LOWER LAKE DAM

NDI - PA 00306

PHASE I INSPECTION REPORT

NATIONAL DAM INSPECTION PROGRAM

Plate 6
Lower Lake Dam
NOT TO SCALE

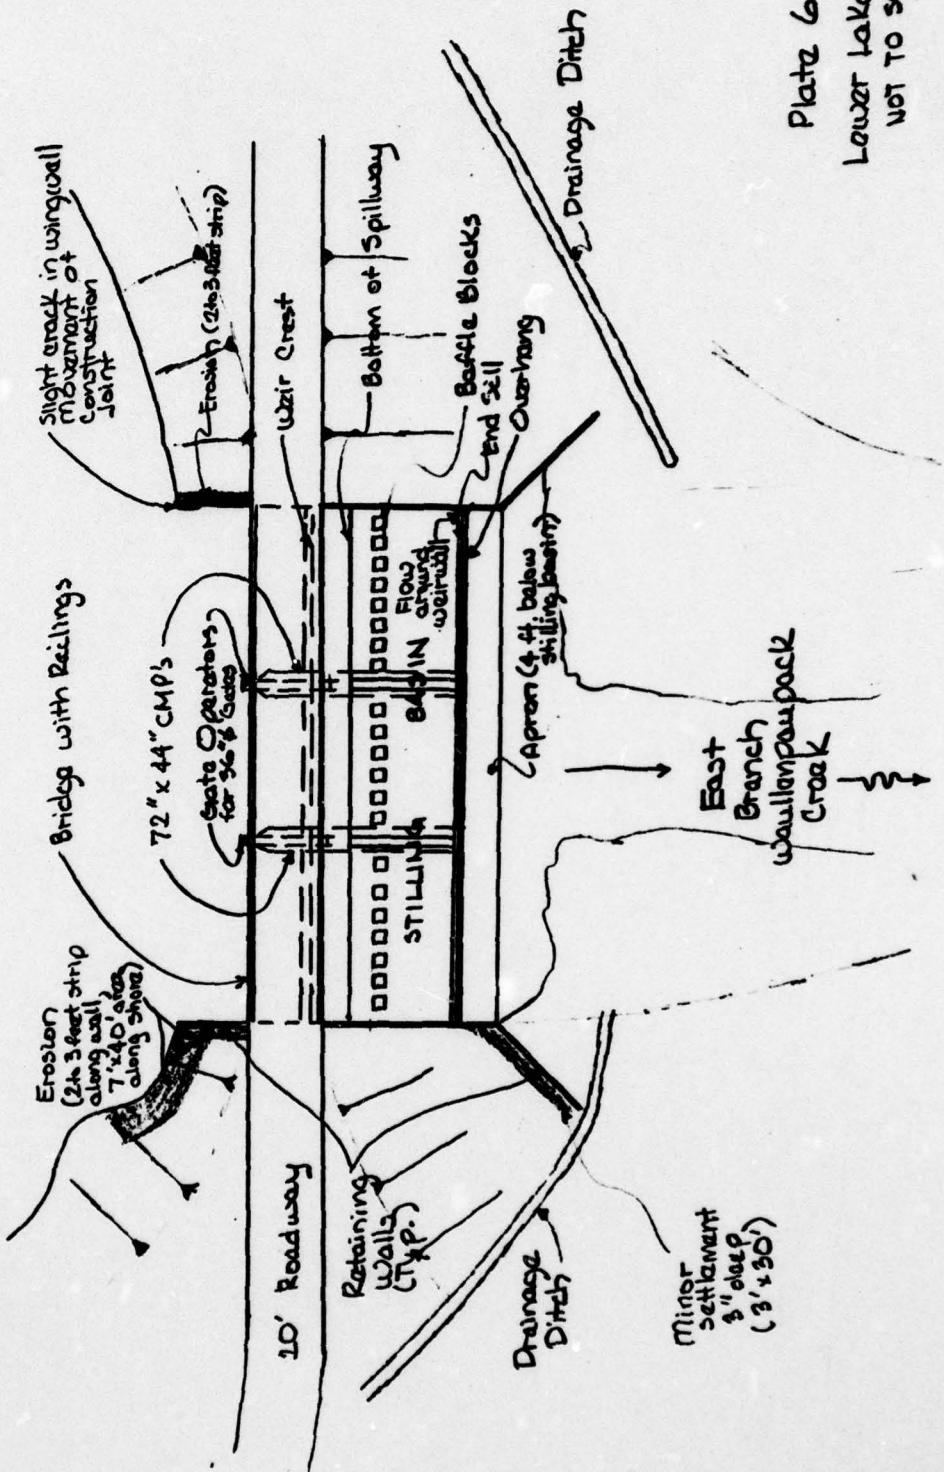
- a. Visual Observations. Riprap facing on the upstream slope of the embankment is missing or covered by grass and earth. Minor settlement of up to 3 inches of the embankment adjacent to the downstream right wingwall tie-in could be due to poor compaction of earth adjacent to wingwall.

A crack at the upstream end of the left wingwall at the tie-in and movement of an adjacent construction joint of approximately 1/4 inch were observed. However, this should have minor effect on the overall stability of the structure. Occasional hairline cracking and spalling of the wingwalls were noted.

1. Eroded areas on the upstream face of the embankment should be filled; graded filter and riprap should be provided where wave protection is inadequate.
2. The area of settlement adjacent to the right wingwall on the downstream side should be excavated several feet and the backfill material compacted. Monthly observations should be made to check for settlement.
3. The crack in the upstream side of the left wingwall and the adjacent construction joint should be monitored for further movement.
